PCN-244123

Product Change Notice

NiPdAu pre-plated lead-frame

Current

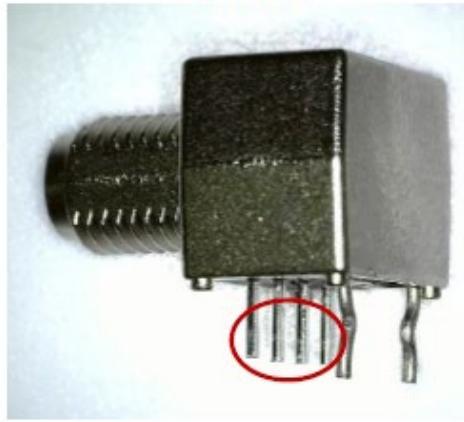
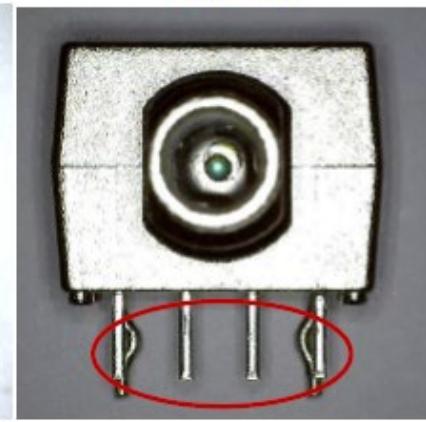
Active pins (pin5, pin6, pin7 and pin8 in red circle): Affected by changing to new NiPdAu lead-frame finish.

Staple pins or Metal shield mounting pins (pin1, pin2, pin3 and pin4): No Change.
